**FINAL DRAINAGE REPORT  
FOR  
LATIGO TRAILS FILING NO. 9  
AND  
ADDENDUM TO MASTER DEVELOPMENT/  
PRELIMINARY DRAINAGE PLAN  
FOR LATIGO TRAILS,  
EL PASO COUNTY, COLORADO**

June 2022

PCD File No.: SF2136

LATIGO TRAILS FILING NO. 9  
DRIVEWAY CULVERT EXHIBIT  
JOB NO. 2517502  
6/14/2022  
SHEET 1 OF 1

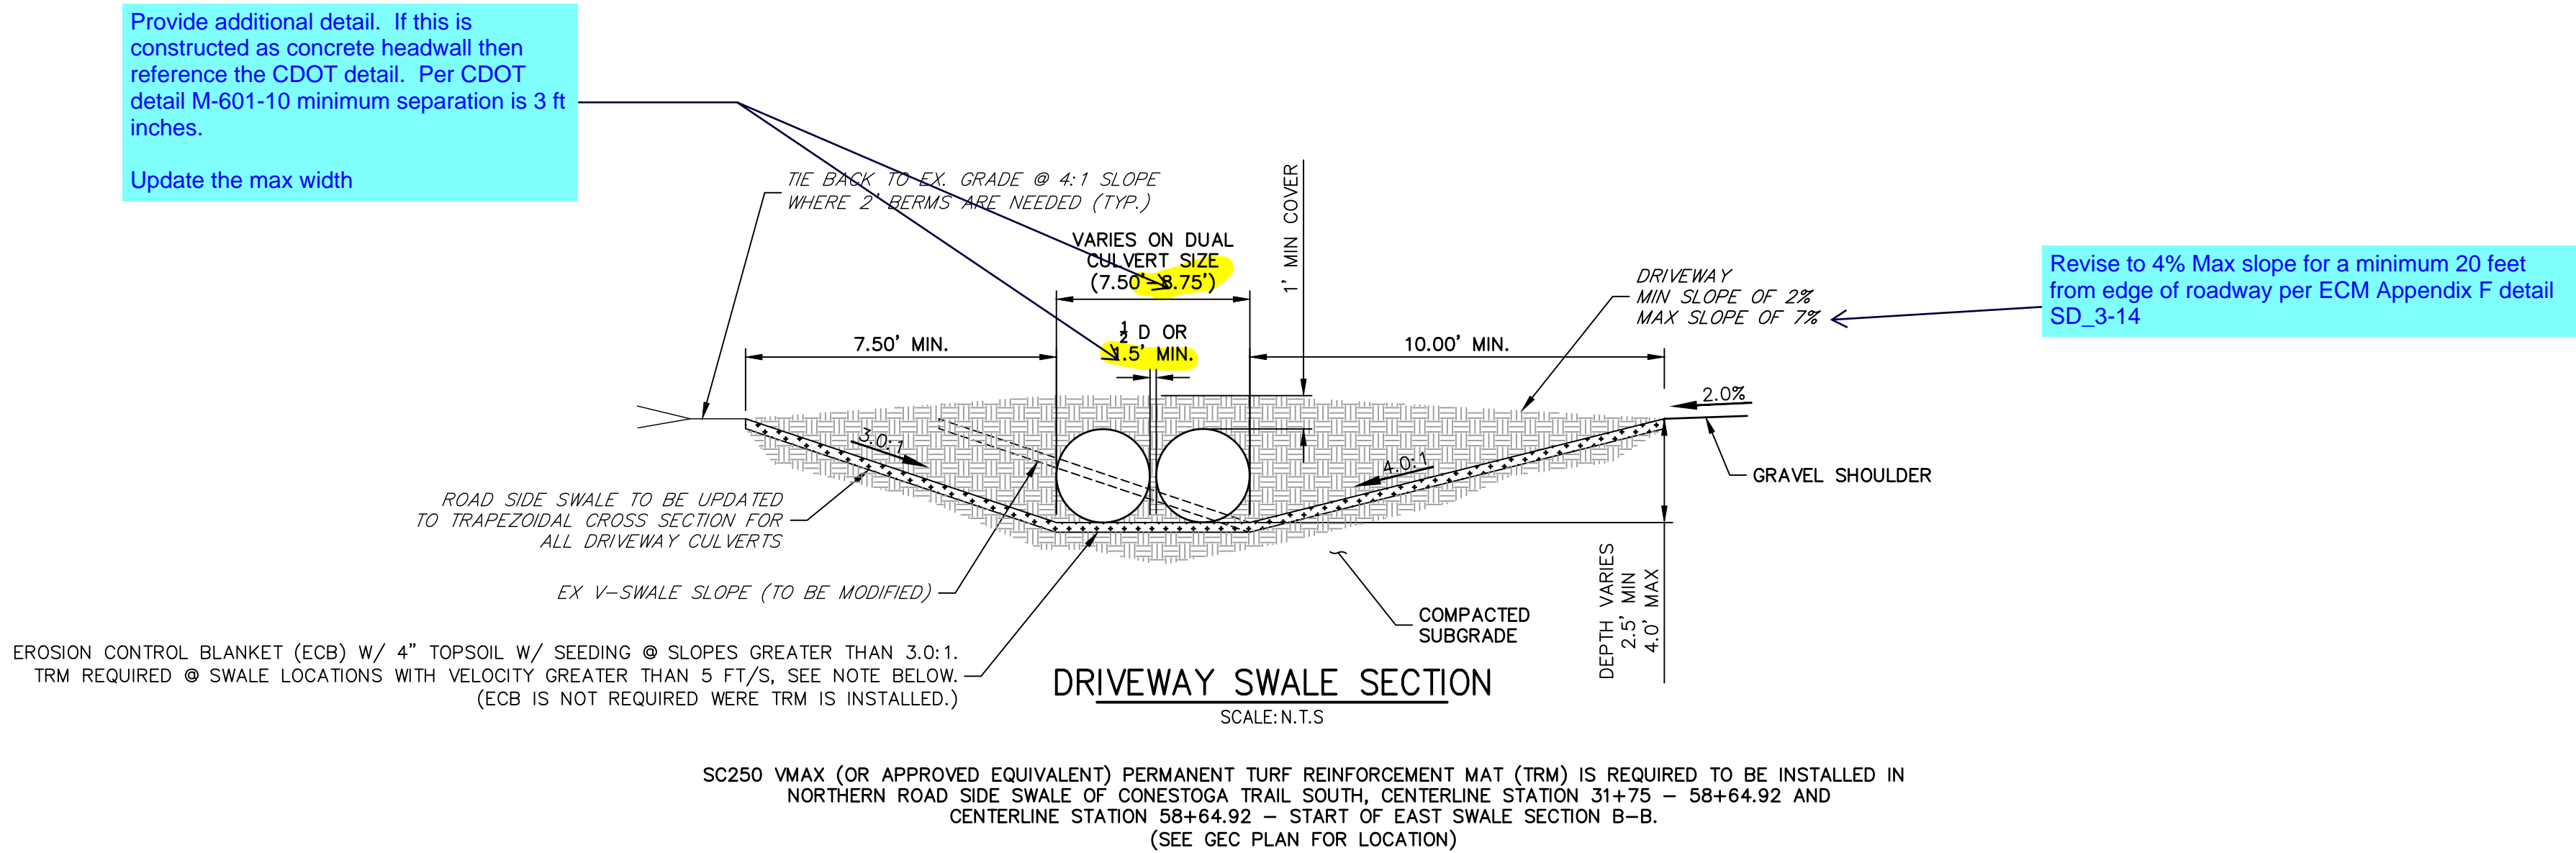
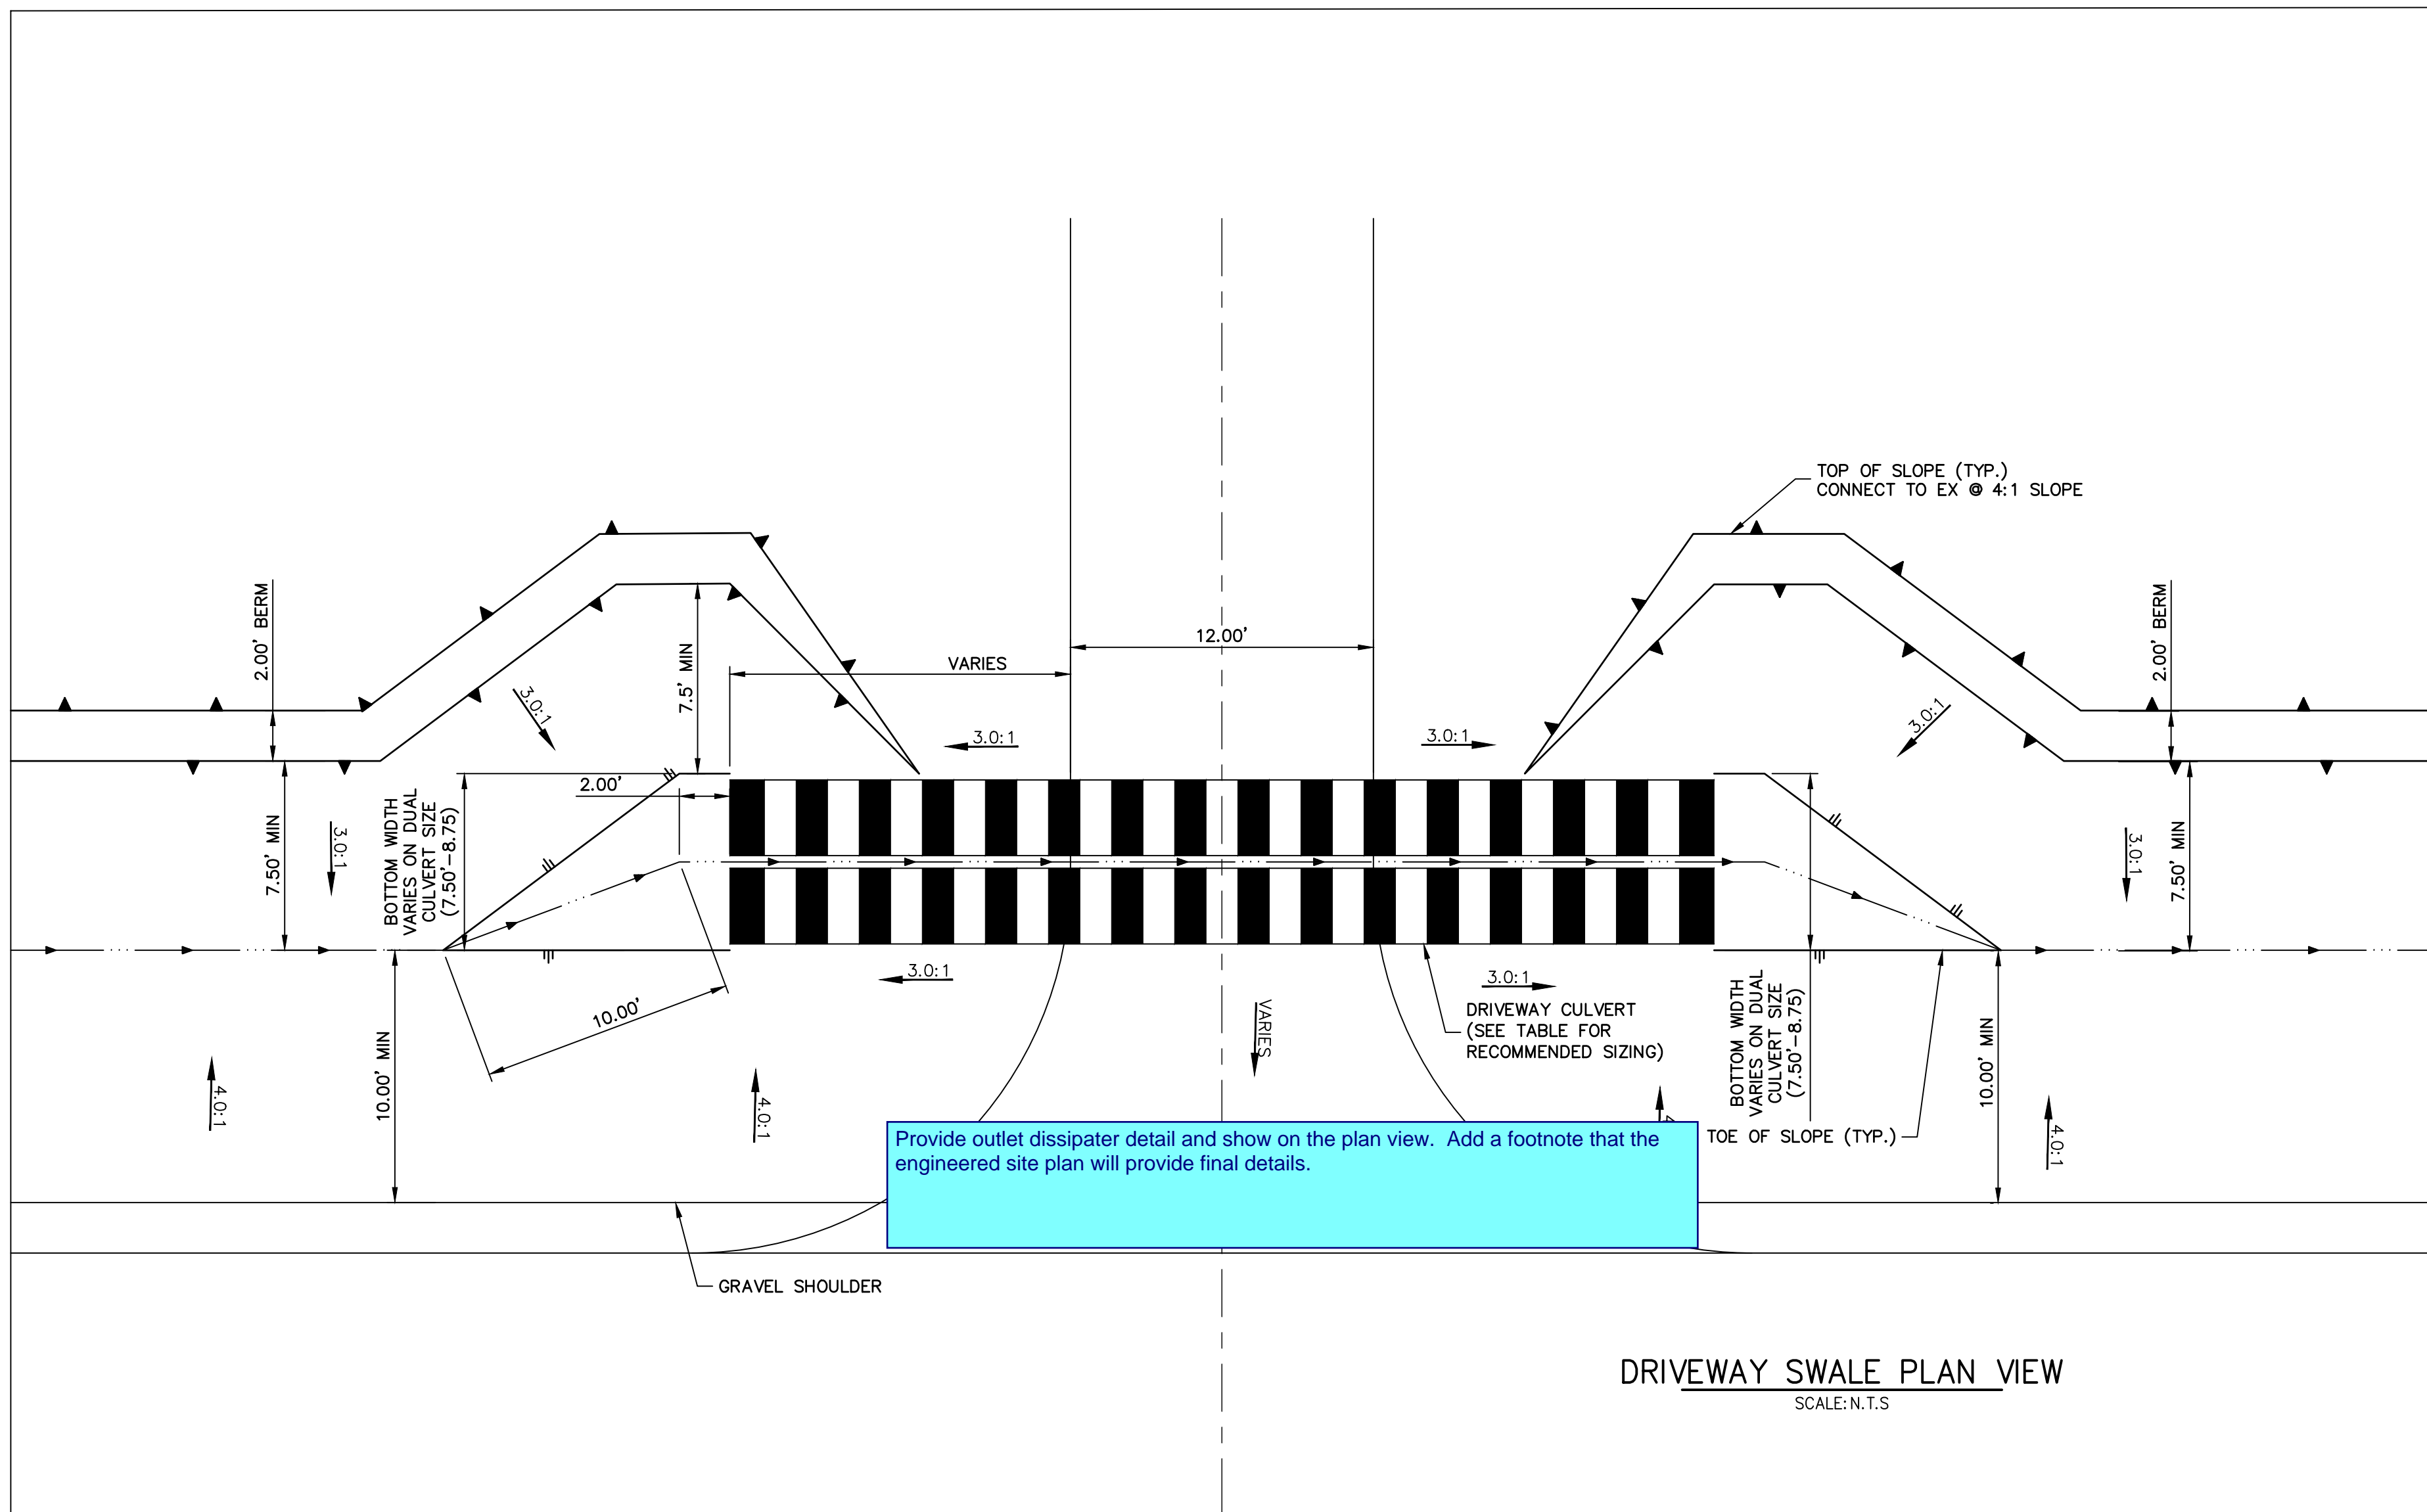
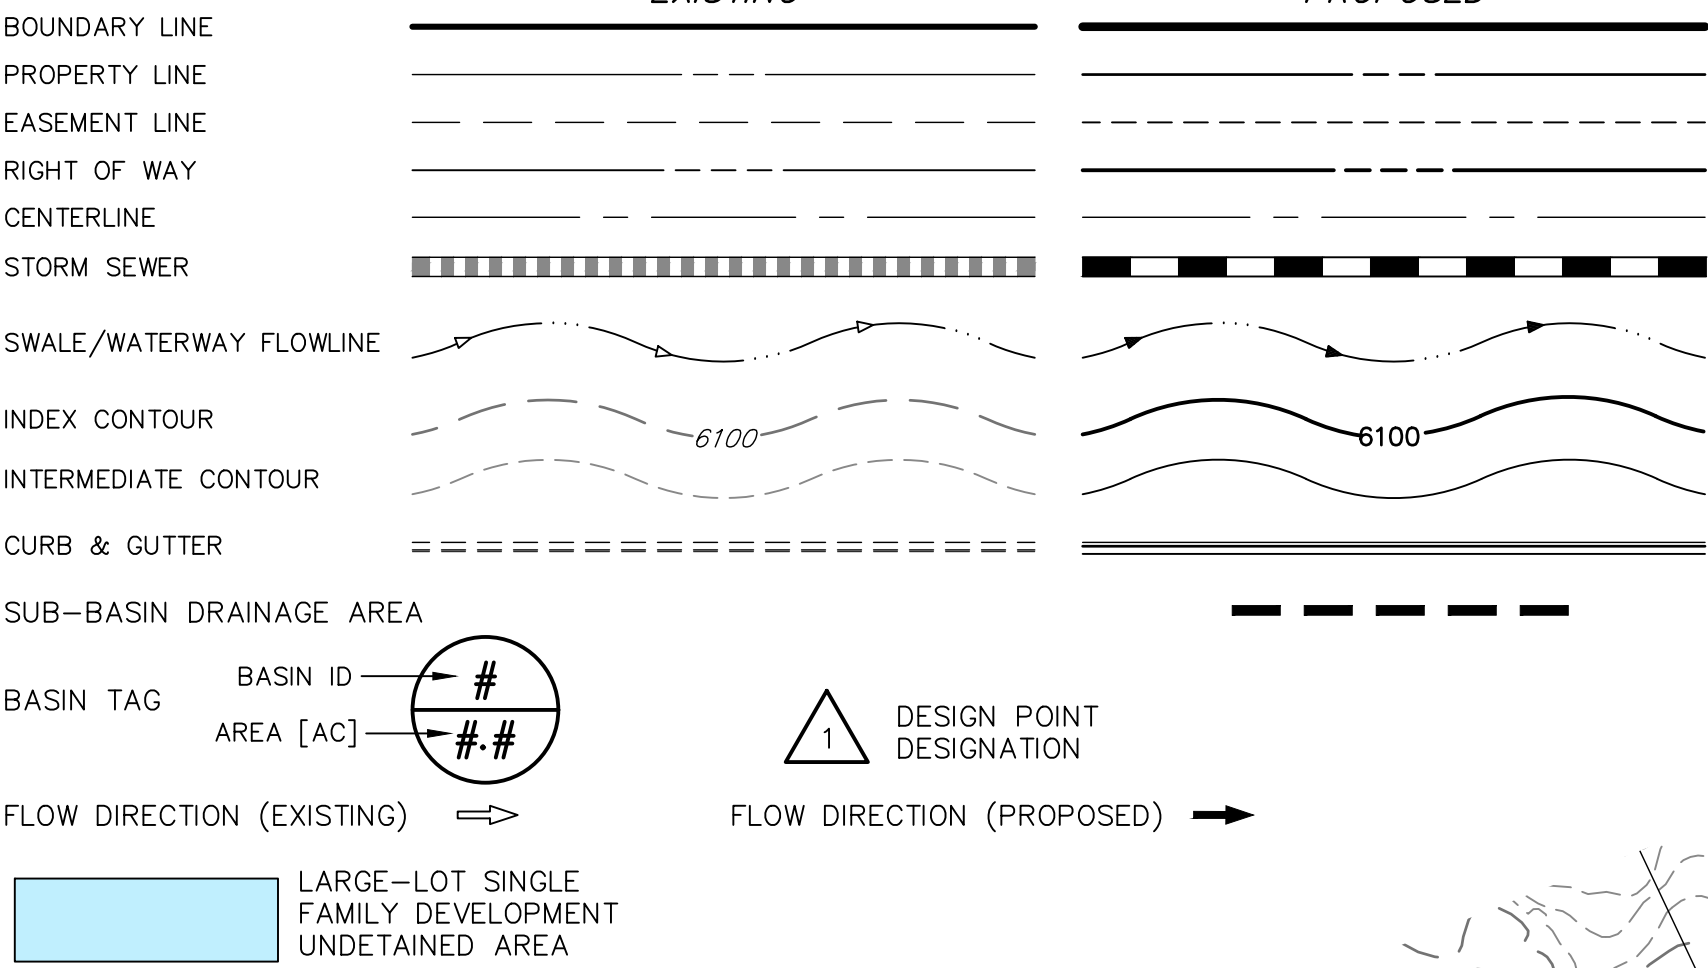
Show the typical ROW and drainage easement location on both the plan view and profile view

Revise statement. The maximum of 6" over-topping is measured at the shoulder, not the centerline.

Clarify note by specifying the required length.

Revise to 4% Max slope for a minimum 20 feet from edge of roadway per ECM Appendix F detail SD\_3-14

Provide outlet dissipater detail and show on the plan view. Add a footnote that the engineered site plan will provide final details.

Provide additional detail. If this is constructed as concrete headwall then reference the CDOT detail. Per CDOT detail M-601-10 minimum separation is 3 ft inches.
